ADDENDUM NO. 2

PROJECT NAME: East Campus Recreation Center Renovation & Addition
UNL PROJECT NUMBER: A016P039
BID INVITATION NUMBER: 2237-13-7200

CONSULTANT: Sinclair Hille & Associates, Inc.
ADDRESS: 700 Q Street
Lincoln, NE 68508

The bid documents, plans dated 8/21/13 and project manual dated 8/25/13, for the above referenced project are amended by this addendum.

11 PLAN @ COL. 'L-4.1', MEZZANINE LEVEL
 S310 3/4" = 1'-0"

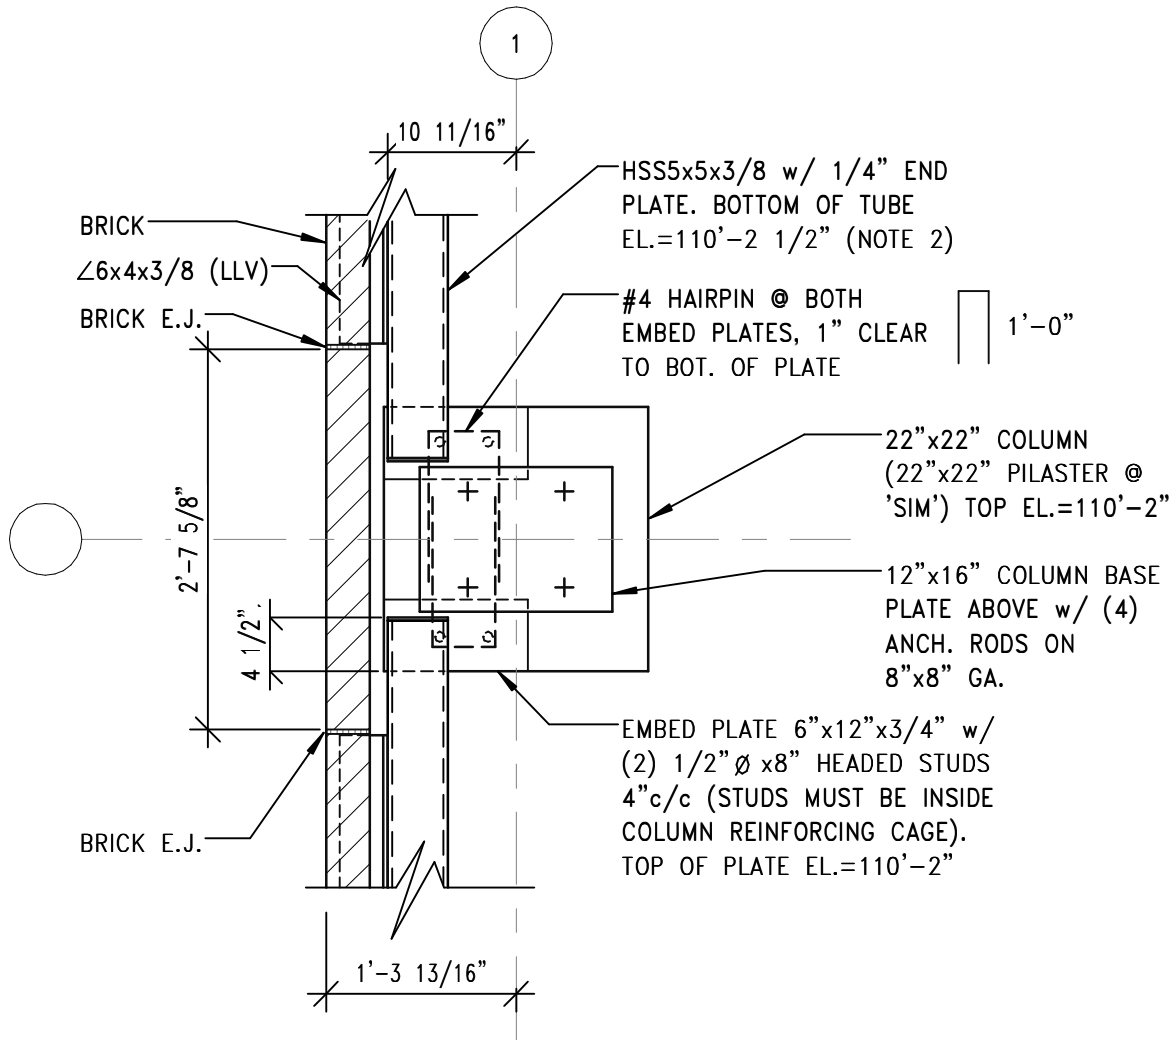
- ADD 2-59.** Refer to Sheet S103, Mezzanine Level Framing Plan; At column 'L-4.1', reference plan detail 11/S310.
- ADD 2-60.** Refer to Sheet S103, Mezzanine Level Framing Plan; At column 'K-9', revise plan note number referenced from 32 to 40.

14 PLAN @ BRICK LEDGE ANGLE
S310 1 1/2" = 1'-0"

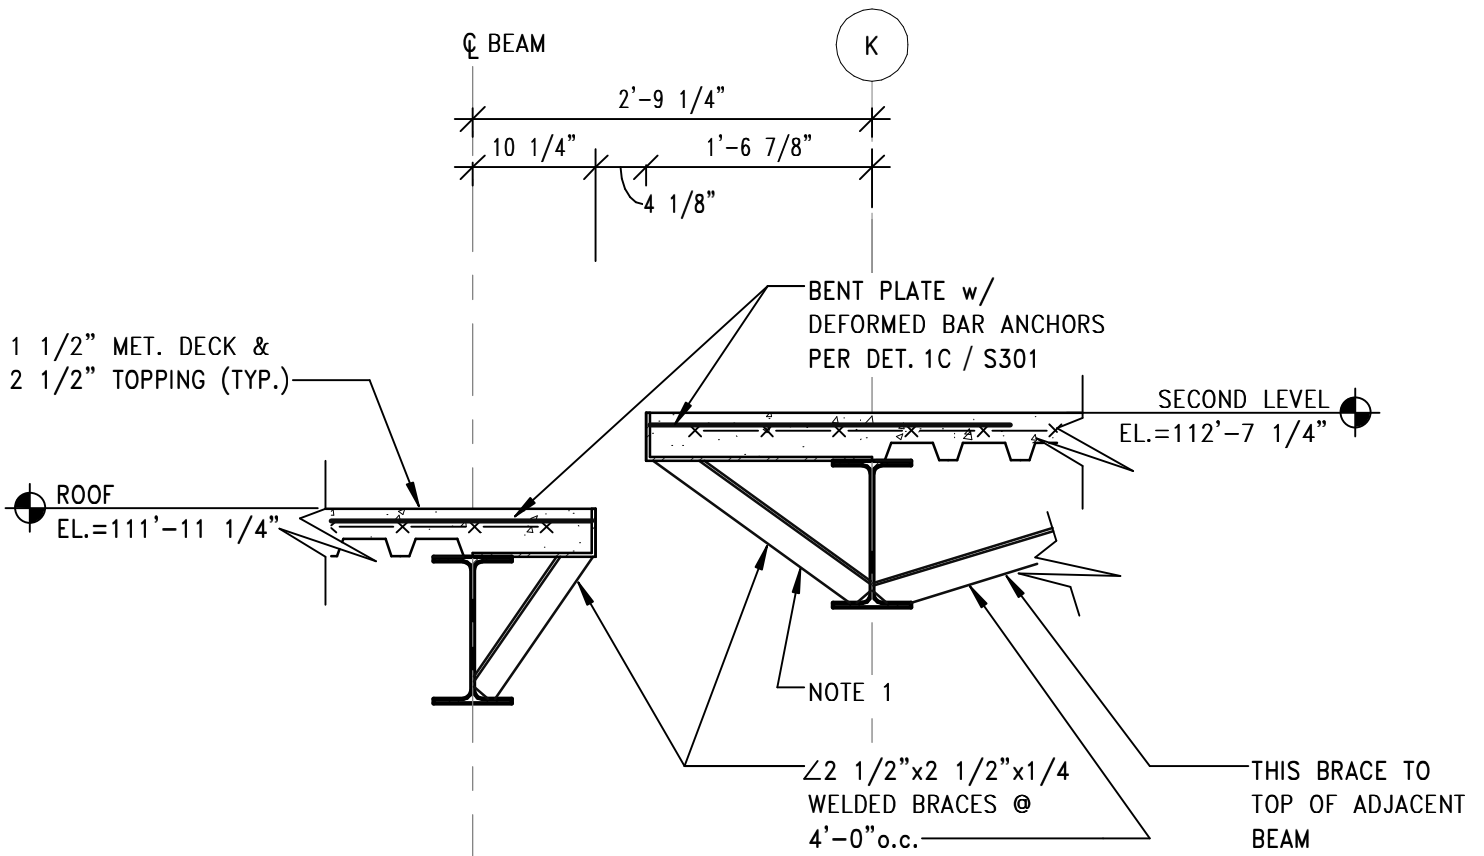
- ADD 2-70.** Refer to Sheet S310, Framing Details; Add Details 9/S310 through 15/S310 as shown on **Attachments S310-A, S310-B, S310-C, S310-D, S310-E, S310-F and S310-G.**

FRAMING @ CEILING HUNG TOILET PARTITIONS

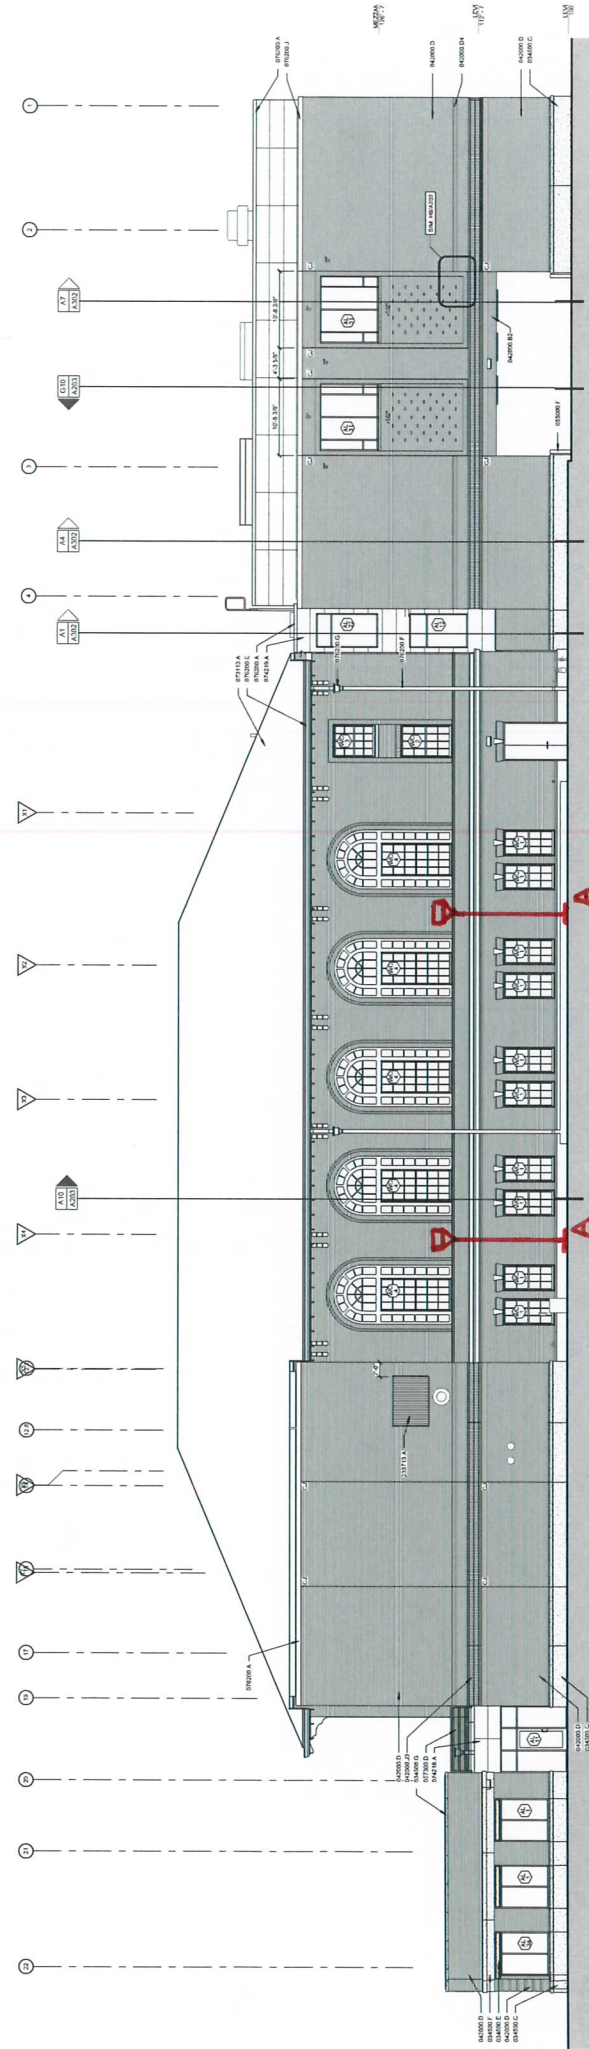
- ADD 2-73.** Refer to Sheet S502, Framing Details – Existing Building; Add Detail 19/S502 as shown on **Attachment S502-A.**
- ADD 2-74.** Refer to Sheet S503, Framing Details – Existing Building; Add Detail 5/S503 as shown on **Attachment S503-A.**
